NO: SW - 134	PRODUCT: B3F-6000 Series – Tactile Switch
DATE: November 2020	TYPE: Modification – Change to Box Material

B3F-6000 Series Tactile Switch - Change to Box Material

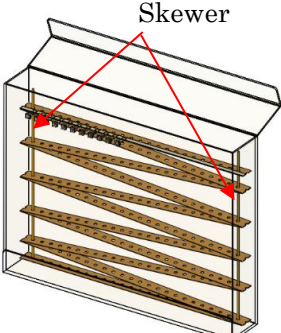
In an effort to improve quality, Omron will change the box material of the B3F-6000 Series from paper to plastic and will add 'skewers' to assist with paper tape alignment and extraction from the box. This change will be effective as of our production in May 2021. There will be no impact on technical specifications, changes to part numbers, package quantities or prices as a result of these changes. The following details will fully explain the changes and part numbers affected. Should you have any additional questions, please communicate with the Switch and Connector product Manager, Patrick Lahey.

Before the change	After the change
<p>Packing box material: Paper</p> <p>Appearance:</p> 	<p>Packing box material: Plastic</p> <p>Appearance:</p>  <p>Packing form: Skewers inserted to assist with alignment and extraction.</p>
